UNITED STATES PATENT AND TRADEMARK OFFICE

10/538,402

Office Action Summary	Application No. 10/538,402	Applicant(s) WANG ET AL.	
	Examiner BRYAN D. RIPA	Art Unit 1795

DETAILED ACTION

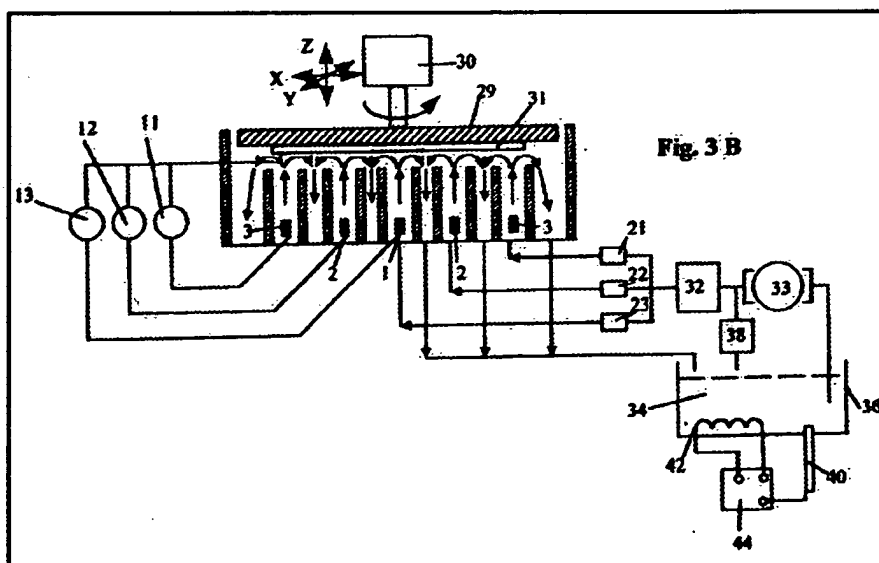
- a receptacle having a plurality of section walls (see figure 3b below showing a cup-type receptacle having a plurality of section walls; see also page 27 line 26- page 28 line 16); and
- a wafer chuck configured to hold the semiconductor wafer and to position the semiconductor wafer within the receptacle with a surface of the semiconductor wafer adjacent to top portions of the plurality of section walls (see 29 below).

Regarding claim 4, WANG teaches the apparatus for electropolishing and/or electroplating metal layers on a semiconductor wafer wherein the plurality of section walls are cylindrical and concentric (see figure 3b above).

- positioning a wafer chuck holding a semiconductor wafer within a receptacle having a plurality of section walls, wherein a surface of the semiconductor wafer to be electropolished or electroplated is positioned adjacent to top portions of the plurality of section walls (see wafer chuck 29 and figure 3b above showing a cup-type receptacle having a plurality of section walls; see also page 27 line 26-page 28 line 16).

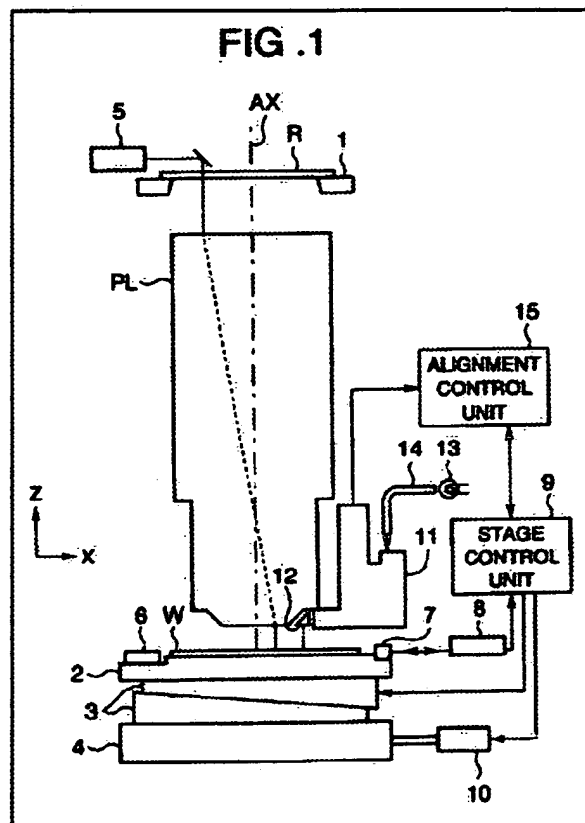
MIZUTANI, however, teaches the use of sensors to measure alignment of a wafer holder having a wafer disposed within it and an exposure apparatus (see laser interferometer 8 in figure 1 below; see also col. 3 lines 51-58).

MIZUTANI, however, teaches the use of sensors to measure alignment of a wafer holder having a wafer disposed within it and an exposure apparatus (see laser interferometer 8 in figure 1 above; see also col. 3 lines 51-58).
